Extended Power baseline proposal

v220

Replace Figure 33-18

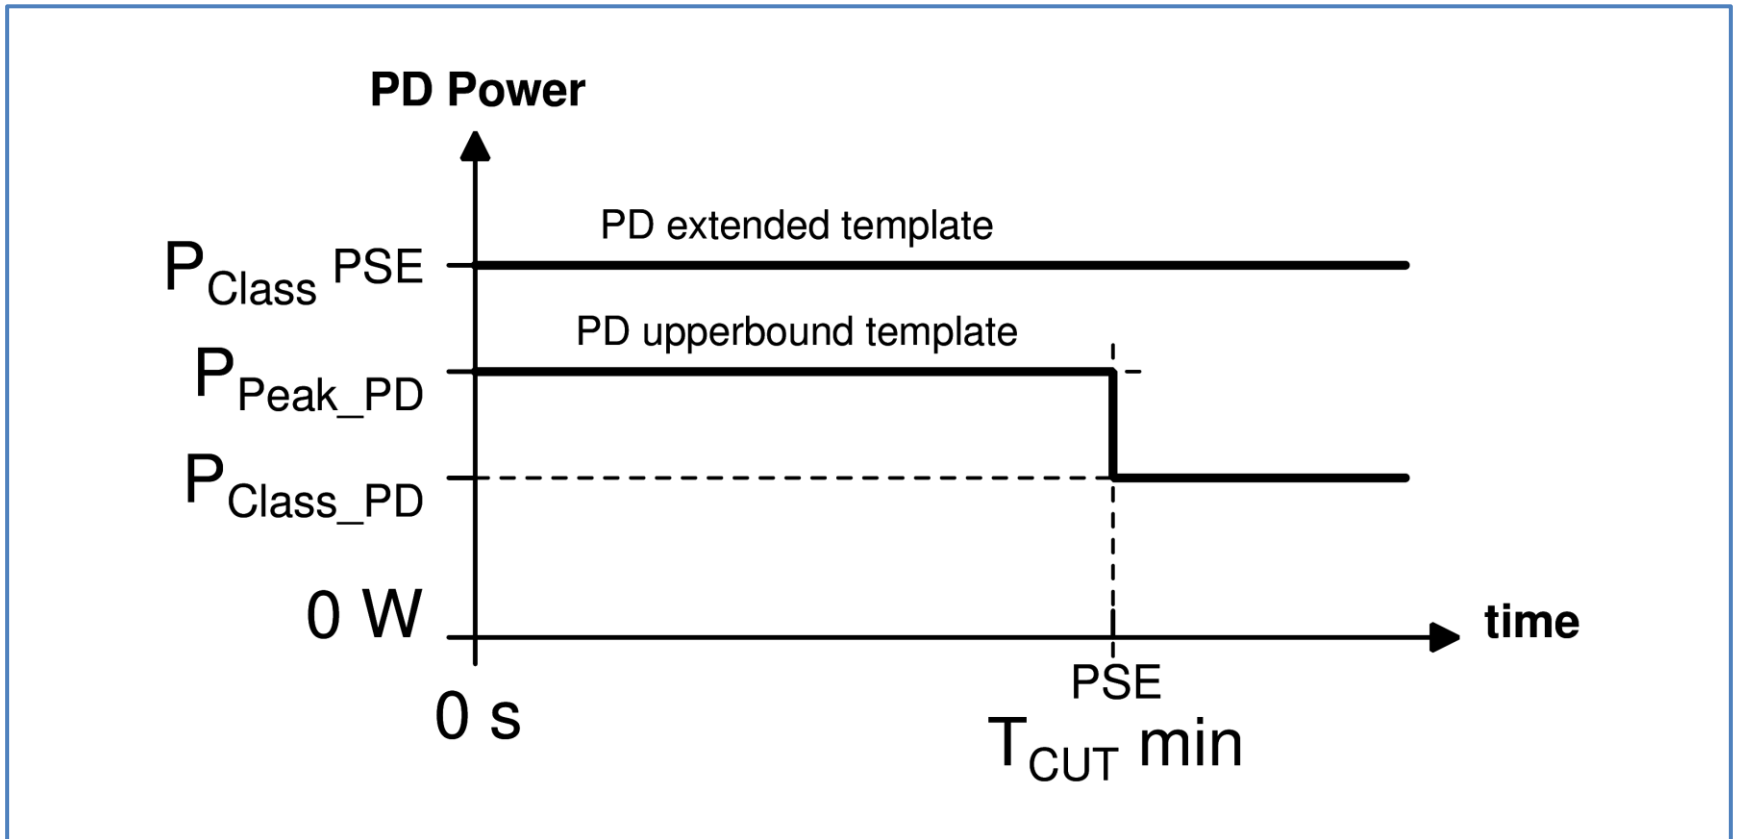
Replace:

Under normal operating conditions when there are no transients applied at the PD PI, the PD shall operate below the PD upperbound template defined in Figure 33–18.

By:

Under normal operating conditions when there are no transients applied at the PD PI, Type 3 and Type 4 PDs shall operate below the PD extended template define in Figure 33-18. Type 1 and Type 2 PDs, or PDs that cannot guarantee that the PSE will source less than P_{class} shall operate below the PD upperbound template defined in Figure 33-18.

Note: this text & figure do not allow the PD the exceed the upperbound template unconditionally. The condition is that the PSE does may not be caused to exceed sourcing P_{class} , this restriction is handled in section 33.3.7.2.

The PD extended template in Figure 33-18, P_{PDET} , is described by Equation (33-xx):

$$P_{PDET}(t) = \{P_{Class} \text{ for } (0 \leq t)\}_w$$

where

t	is the duration in seconds that the PD sinks I_{port}
P_{Peak_PD}	is the peak operating power, $P_{peak_Pd}max$, as defined in Table 33-18
P_{Class_PD}	is the maximum power, $P_{class_Pd}max$, as defined in Table 33-18
P_{Class}	is the minimum power output by the PSE, as defined in Table 33-7 and section 33.2.6
